REVIEW OF BETTER APARTMENTS DRAFT DESIGN STANDARDS

Figure 1 – Room depth to height ratios for single or double aspect apartments (not south facing). Diagram from better Apartment Draft Design Standards

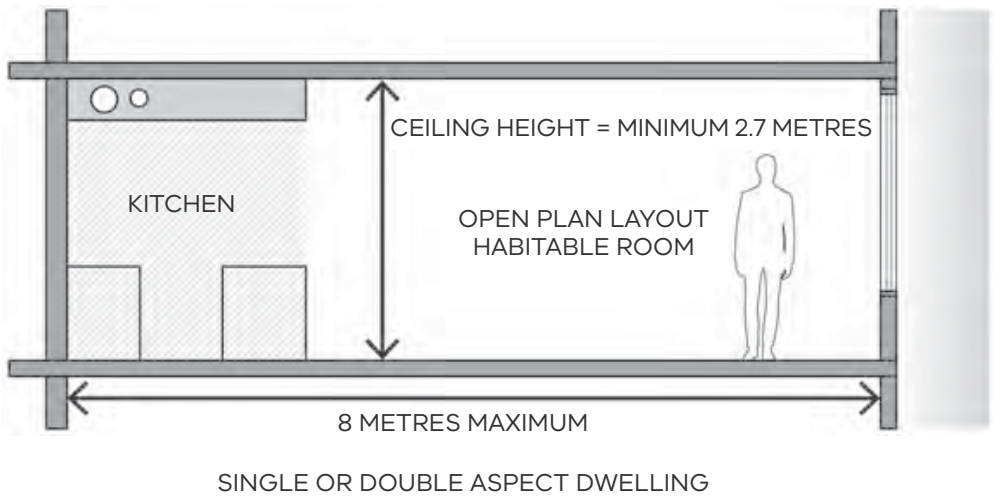
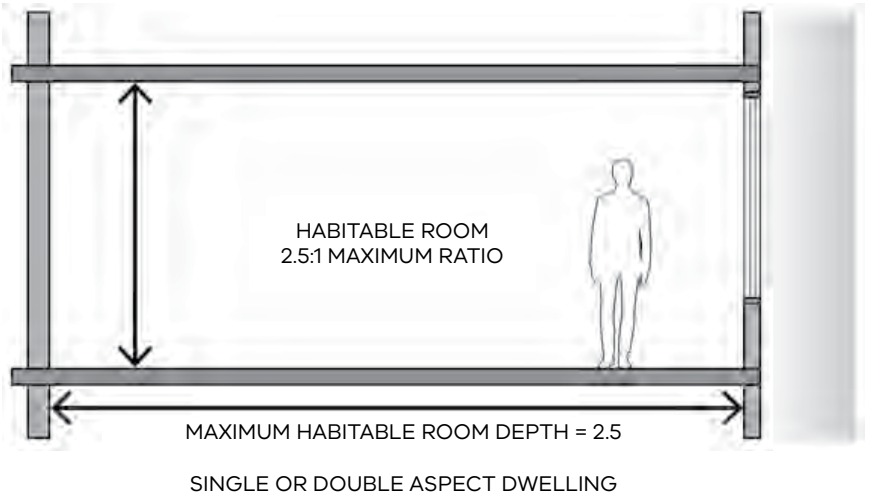
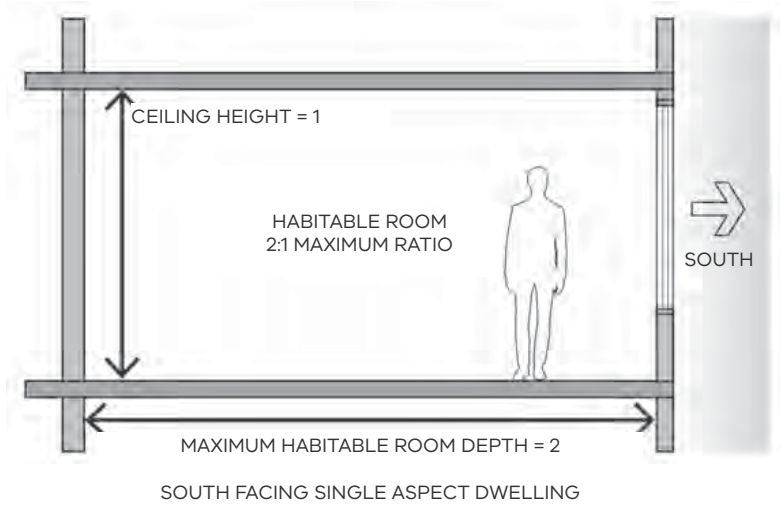
- The standard adopts a deemed to satisfy approach without reference to the multitude of factors which can effect daylighting. The lack of logic in the standard is perhaps no better illustrated than by the complete omission of any discussion regarding window sizes or glass colour, design components which have a great influence over daylight levels in an apartment

- The standard as drafted places severe restrictions on how an apartment can be planned. For example, in order to accommodate a dining table and living space in front of an island bench a dimension of 6.5 / 7m is necessary. Adding 2.5 depth for a kitchen requires a room depth of a minimum of 9.0m. The example apartment included in the document does not allow space for a dining table which, from many hours spent in multiple sales suites, we know is a prerequisite of the vast majority of apartment purchasers. Whilst we might like to think the kitchen bench can also serve as the dining space this is a construct of the designers and not a view shared by apartment owners

- As well as the deemed to satisfy option the standard should offer an alternate, performance based, method for achieving the objective. We recommend that defined, understood and measurable metrics for daylight be ascribed to habitable rooms. These metrics should be carefully considered and realistic and be provided by a specialist consultant. (We note for example that achieving the daylighting standard as defined in BESS, Built Environment Sustainability Scorecard, is extremely challenging). In making these recommendations we have made reference to leading industry experts at ARUP and Aurecon

- Distinction should be made for different daylight provision standards according to the use categories of a particular habitable space. For example, it is widely recognised by existing best practice daylight standards that the daylight levels in a bedroom need not be the same as in a living room. Similarly, kitchens are task orientated environments and people will invariably use lights

Figure 3 – 12.4m x 6.7m 2 bed Apartment Plan

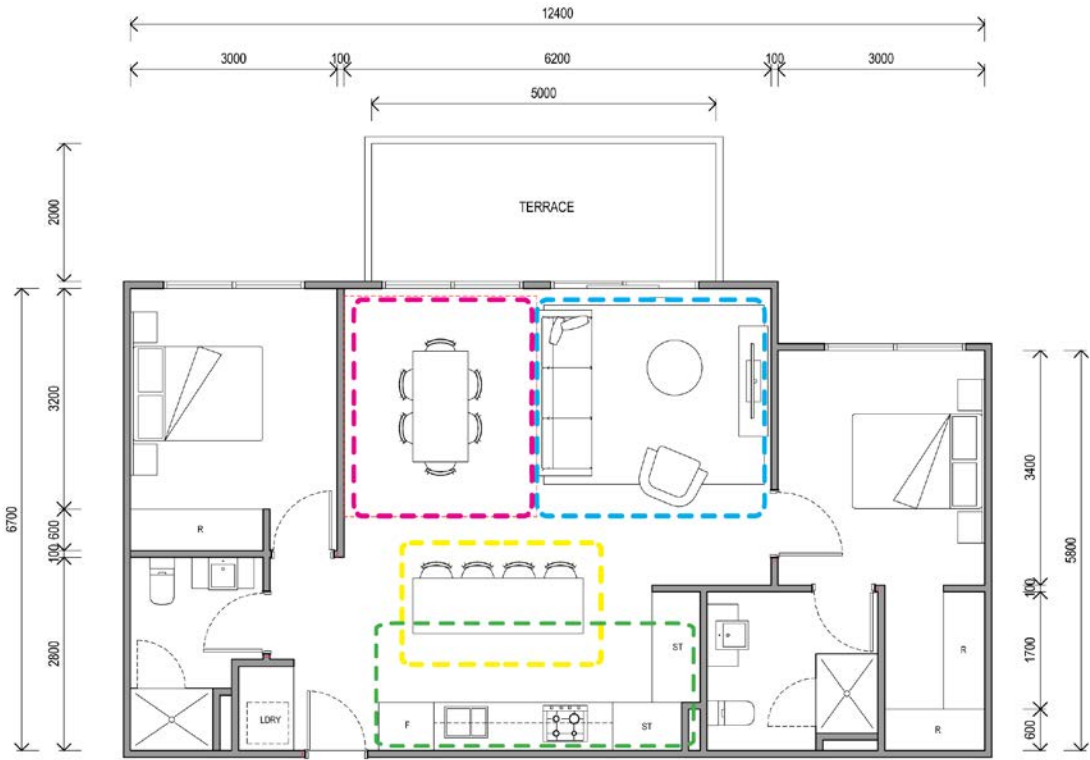
- Similarly, the apartment below, which unarguably provides excellent amenity and would be a good model for a south facing single aspect apartment dimensionally requires a depth of approx. 6.5m and would be precluded by the current standard for a south facing single aspect apartment
- The restrictions on apartment planning as currently defined will have inevitable impacts on apartment affordability

Figure 4 – Window location. Diagram from better Apartment Draft Design Standards

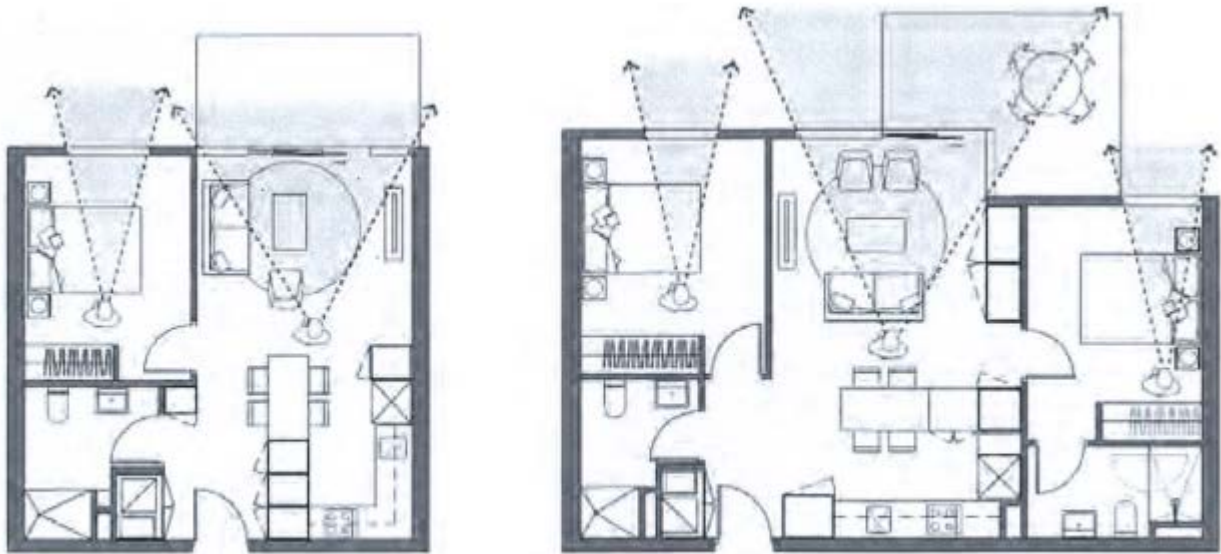
- The standard is poorly drafted and confusing in intent
- That a window should be visible from any point in a bedroom or study is unnecessary and an overtly simplistic control. We suggest that having the window visible from 85% of the room is a far more reasonable and practical standard that will not adversely affect resident's amenity
- If the intent is that all bedrooms are to be located on the perimeter of the building, then the effect on apartment affordability will be considerable

- Access to daylight in a bedroom or study must be via a space of not less than 1.2m wide and a total depth to width ratio of no greater than 1.5:1 where the depth is measured from the external face of the building

Figure 6 – Typical apartment typology from NSW showing need for breeze path longer than 15m

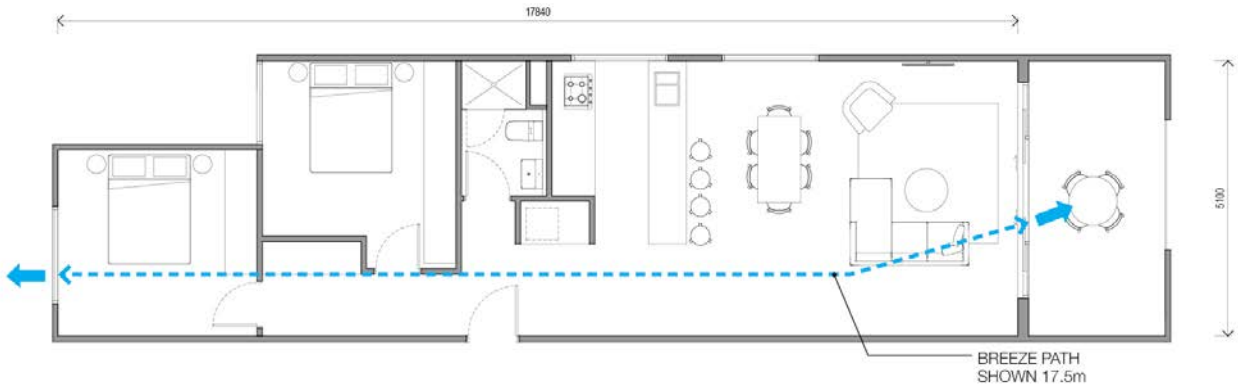
- The 15m breeze path has not been justified and is very restrictive in planning an apartment. For instance, this requirement makes cross ventilating some perfectly reasonable three-bedroom apartment impossible. The breeze path as defined in the NSW apartment design guidelines is 18m so why are we changing this?
- Air moves in response to a pressure differential. It is not particularly concerned if the distance is 15m or 20m
- A performance based standard needs to be added to the standard

- Recommendation that the standard be changed such that at least 50% of dwellings with a finished floor level less than 35 metres height should be naturally cross ventilated. The length of a breeze path through the dwelling should be a maximum of 18m

Figure 7 – Setback diagram from Draft Design Standard

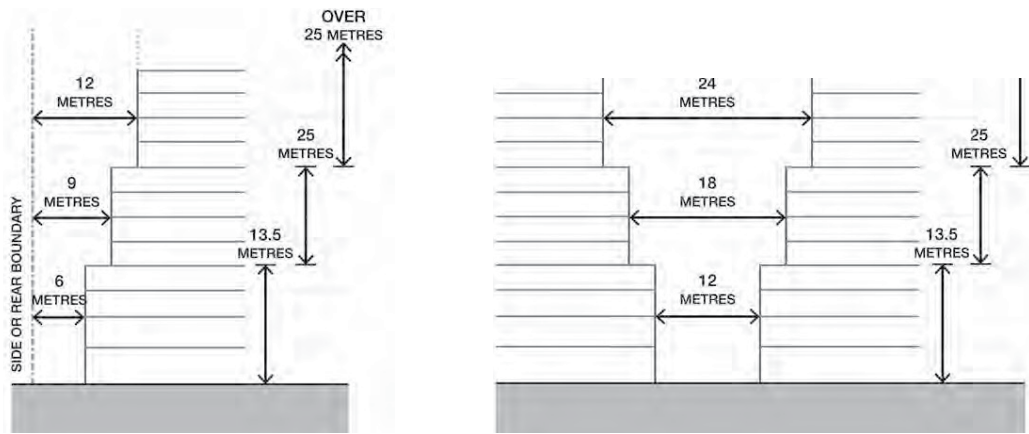
- The standard will adversely affect the capacity for higher density housing in areas not currently the subject of comprehensive development controls. The standard is contradictory to Melbourne's imperative to develop as a higher density more sustainable city of the future
- Setback should be context specific and not mandated by an apartment design guideline
- The heights chosen seem arbitrary and there is no science or reasoning given. The length or depth of a site is not even considered when this will be a significant factor in planning a site
- The setbacks are often contradictory to existing planning controls leading to confusion and uncertainty
- This standard is simply contrary to good urban design which should demand specific responses

- Remove from the document

Figure 11 – Deep Soil Areas. Diagram from Draft Design Standards

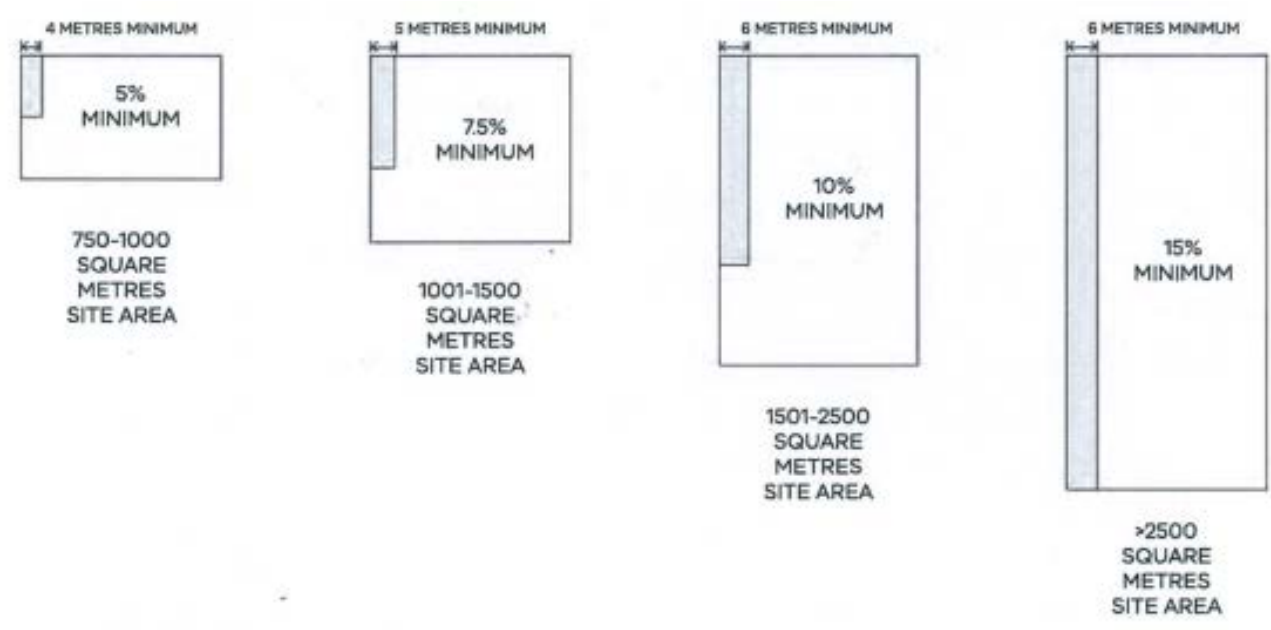
- A poorly drafted standard that is far too open to subjective interpretation
- A one size fits all solution to percentage of site area to be landscaped makes no sense in an urban context
- The controls will often be contradictory to existing planning controls

- Remove from the document

Figure 12 – Example of larger 2 bedroom apartments which would not comply with the Draft Standards

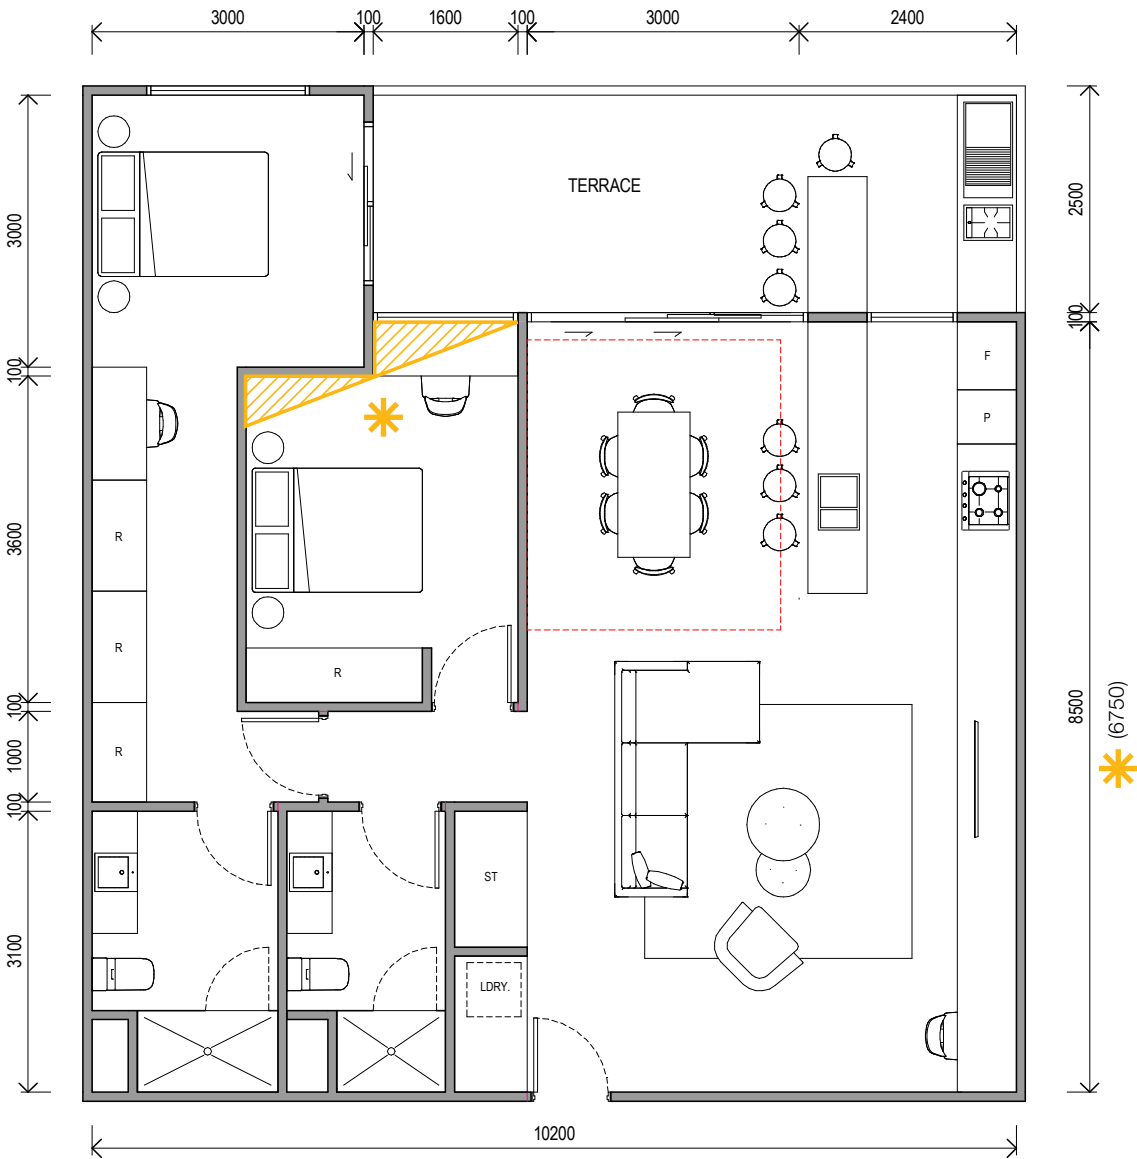
Impetus to introduce the Better Apartments Draft Design Standards has come from a justifiable concern over the amenity of a portion of the recently delivered apartment stock in Melbourne. There is however a growing maturity in Melbourne's apartment market and more owner occupiers are choosing apartment living, particularly in a 5 to 20km radius from the city. In response to this emerging market apartments are being designed that are larger than those which have been the focus of the debate surrounding apartment amenity. They inherently tend to offer excellent amenity but their larger size means that some configurations would not conform with some of the standards as drafted in the draft document, in particular those relating to room depth. We believe that if above 85m2 in area there should be scope to vary some of the metrics in response to purchaser's desire to have more floor area.
